To: All Plan Holders of Record

Re: *Addendum No. 1*
Jefferson Booster Station Replacement
Ashtabula County Board of Commissioners, OH

Date: July 17, 2026

NOTE: THIS DRAWING IS PROVIDED FOR INCLUSION IN BID DOCUMENTS AND FOR INFORMATION ONLY.

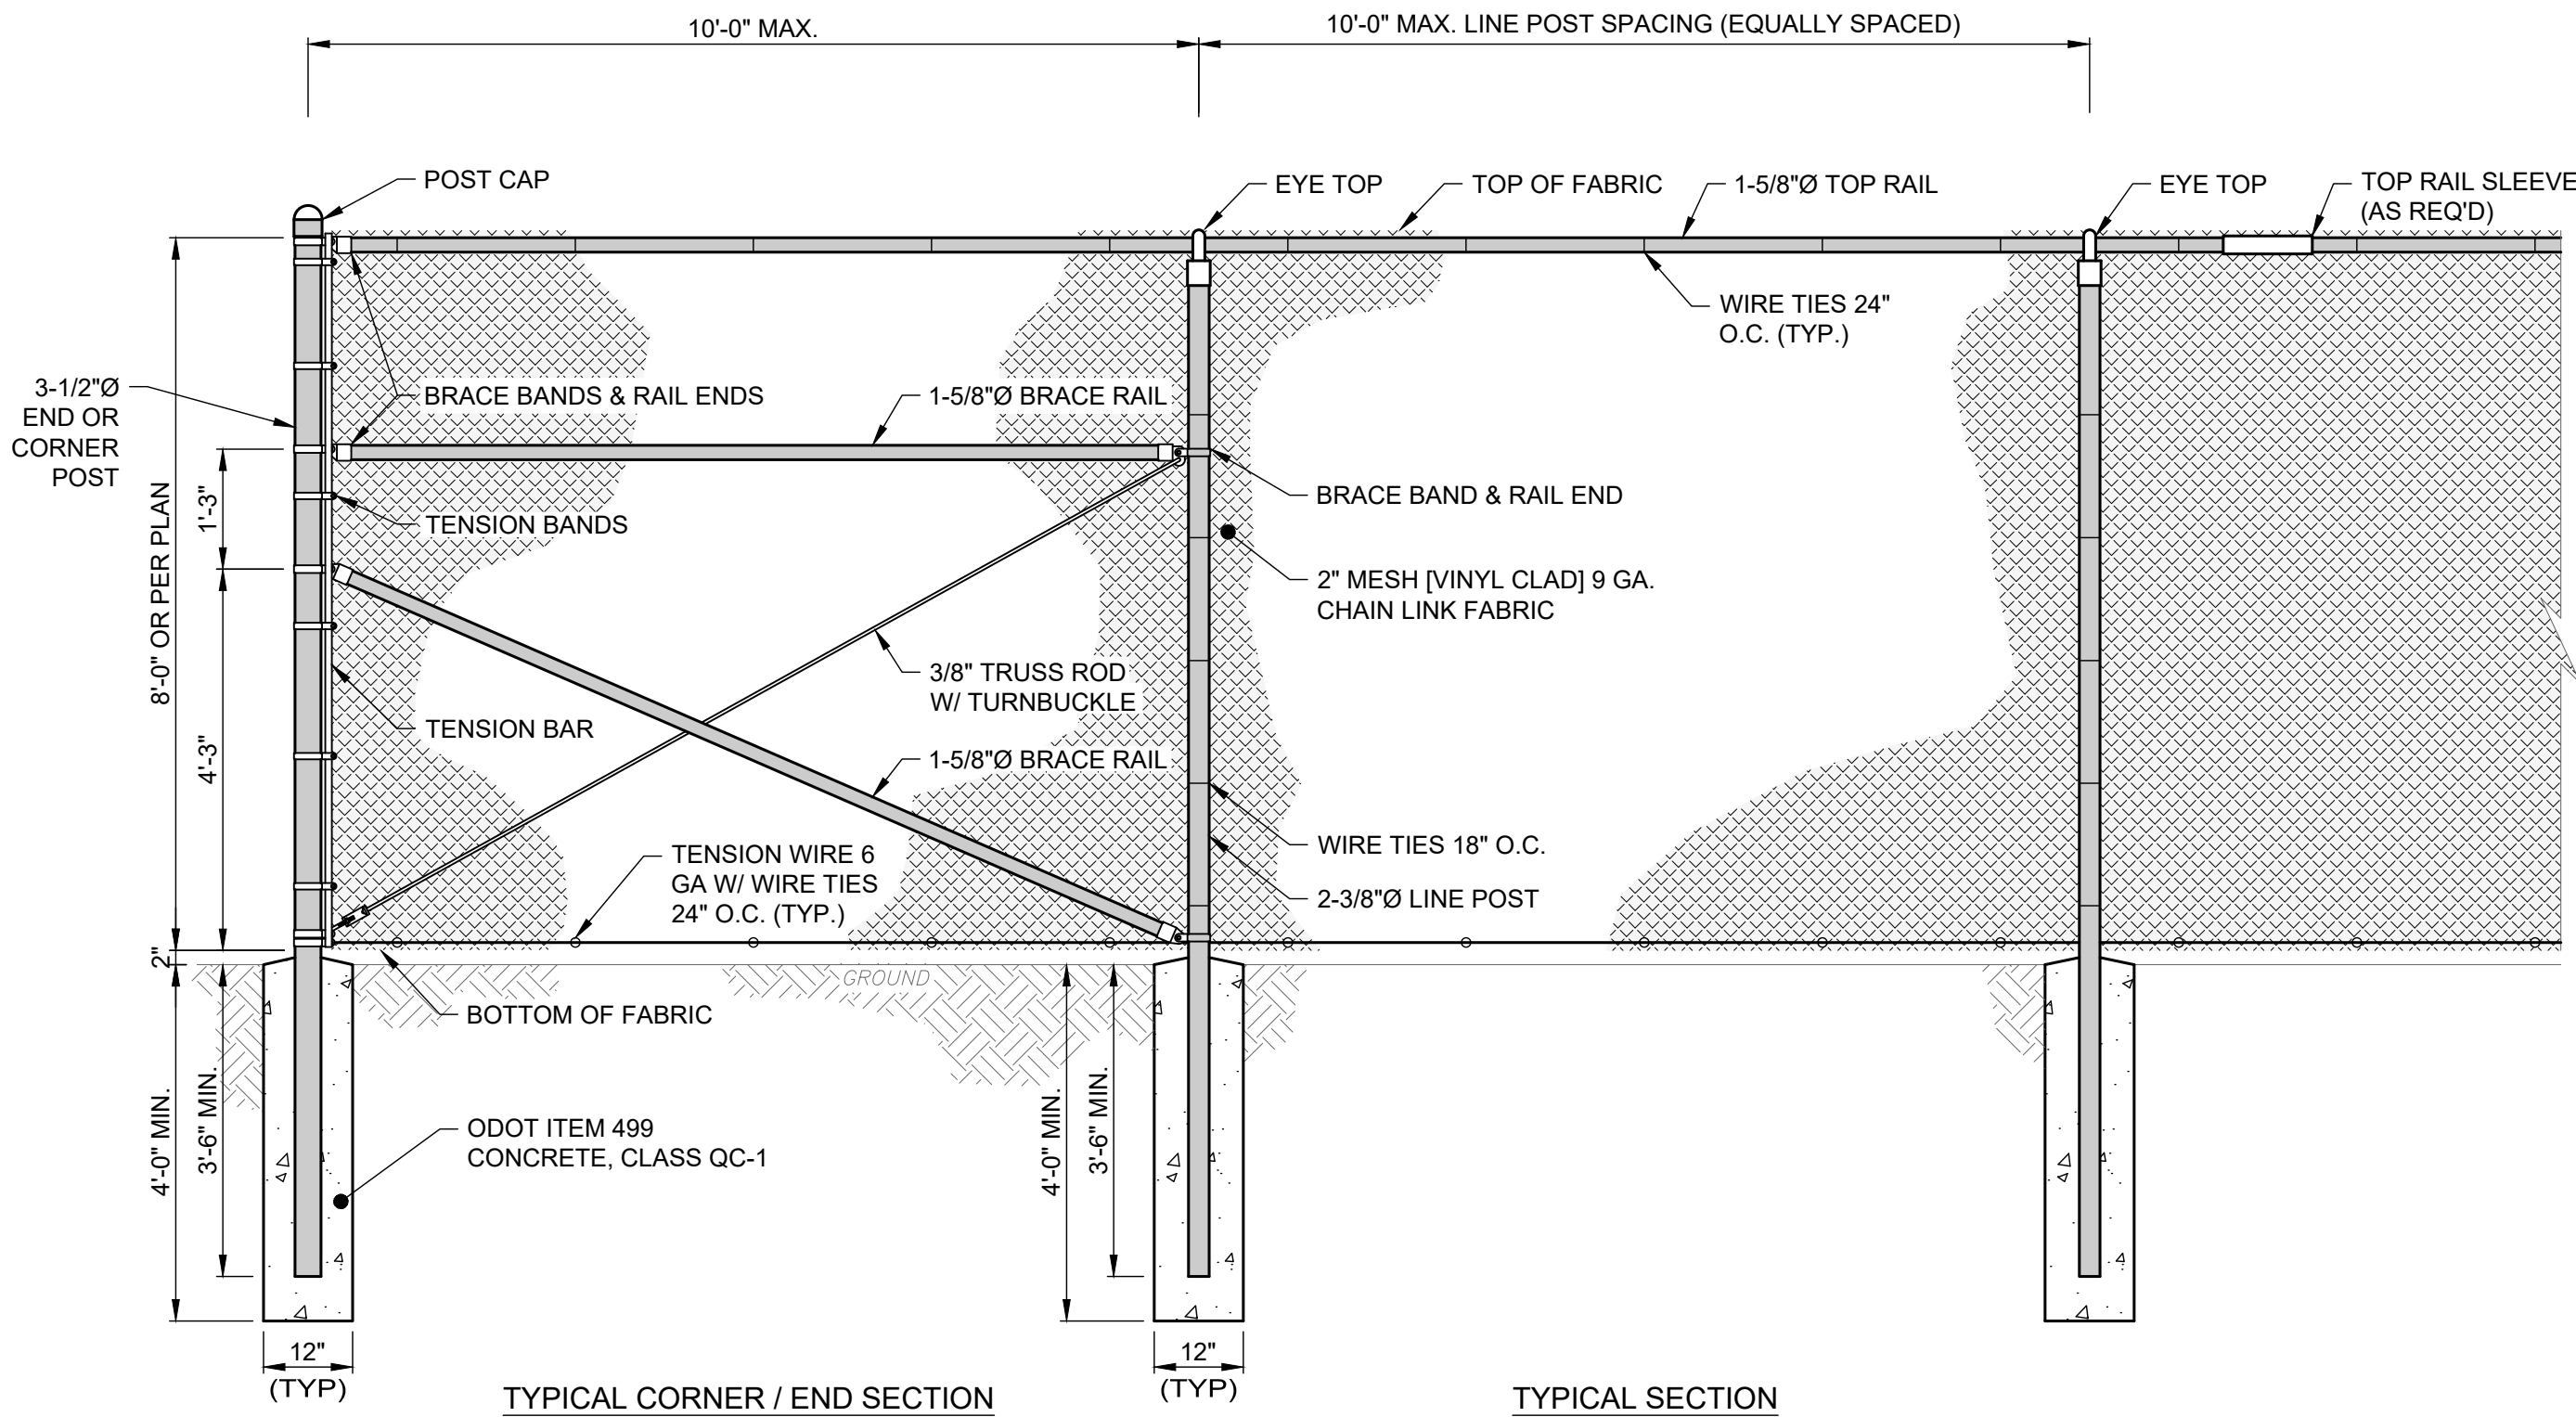
Q7. Can you provide additional details or specifications describing what is required for the exterior of the booster station building.

Replace BOOSTER STATION DETAILS-1, sheet 12/17 with the enclosed BOOSTER STATION DETAILS-1, sheet 12/17.

A7. Faux brick paneling will be applied by the station manufacturer prior to shipment, see modified sheet 12/17.
